## Comments on the Applicant's D1 Submissions

This document sets out the comments by Cambridgeshire County Council (**CCC**) and Fenland District Council (**FDC**) (together, **the Councils**) on the Applicant's Deadline 1 (**D1**) submissions. The tables below set out the document in question that the Councils are commenting on, together with the relevant paragraph or reference number.

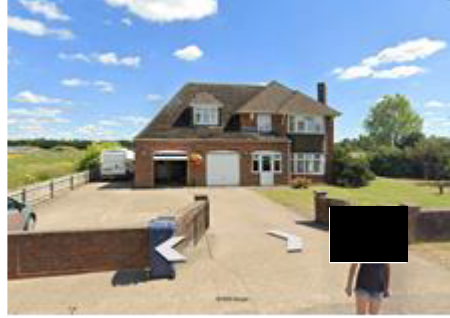
Topic	Paragraph Number	Councils' Comment
Residential property No. 25 Cromwell Road	Table 2.1	The industrial unit the Applicant has referred to has a postcode of PE14 0SD. The residential property at 25 Cromwell Road has a postcode of PE14 0SN and is located opposite Smiths Farm Shop. The following images highlight its position:
